**ASHLAND PLANNING DIVISION
PRE-APPLICATION CONFERENCE
COMMENT SHEET** January 6, 2021

SITE: 364 Walker Ave.
APPLICANT: BBT for ASD
REQUEST: Site Review
Walker Elementary

Prototypical Section: 3-Lane Avenue

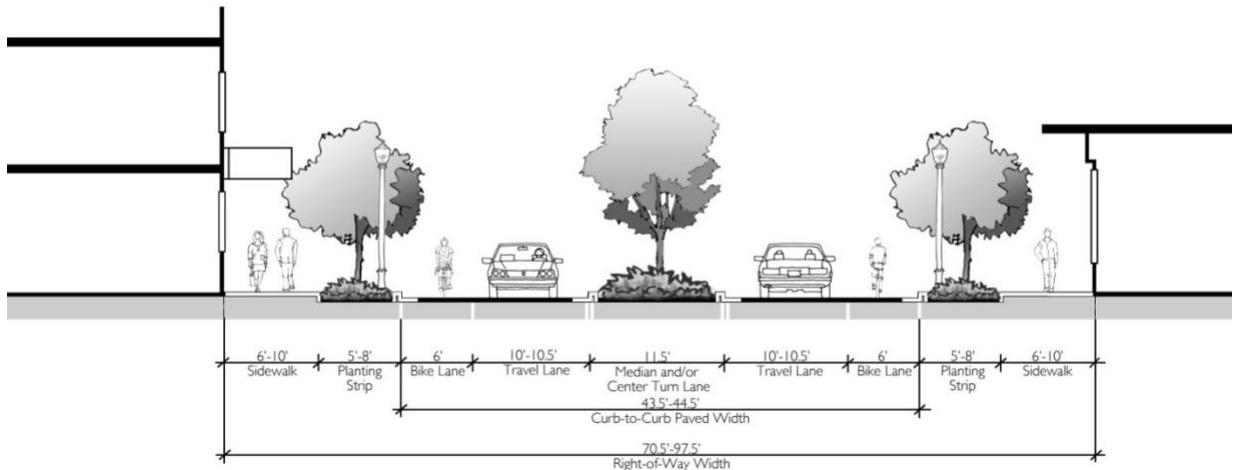
- ✓ Walker Avenue is considered to be an Avenue or Major Collector under the city’s Transportation System Plan or TSP. Street standards for avenues are discussed in AMC 18.4.6.040.G.2 and detailed in the standard cross-section below:

The existing improvement is 33 feet curb-to-curb paved width within a 60-foot right-of-way.

In terms of “controlled access” standards – which seek to limit the number and placement of access points - for collectors these standards generally seek a separation of 75 feet between driveways and placement of driveways at least 50 feet from the nearest intersection.

Prototypical Section: Residential Neighborhood Street, Parallel Parking Both Sides

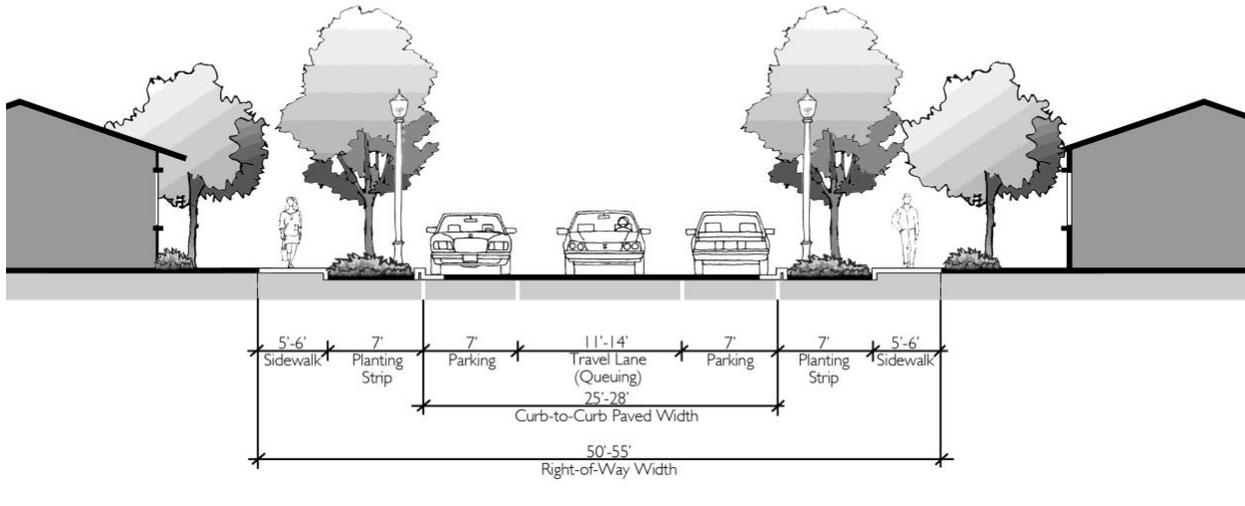
- ✓ Homes Avenue is considered to be a Residential Neighborhood Street under the city’s Transportation System Plan or TSP. Street standards for neighborhood streets are discussed in AMC 18.4.6.040.G.4 and detailed in the standard the cross-section below:

The existing curb-to-curb paved width is 28 feet, however the existing right-of-way width is only 16 feet, with an additional 24-foot ‘street reservation’ on the school side.

In terms of “controlled access”, standards for neighborhood streets generally seek a separation of 24 feet between driveways where there are two or fewer units per lot and a 50-foot separation where there are more than two units, and placement of driveways is to be at least at least 35 feet from the nearest intersection.

Generally, in staff's view the application should look at providing improvements along Hunter Court in a manner consistent with the standard neighborhood street cross-section above, including full-width seven foot park row planting strips with street trees, and provide necessary dedications to support these improvements.
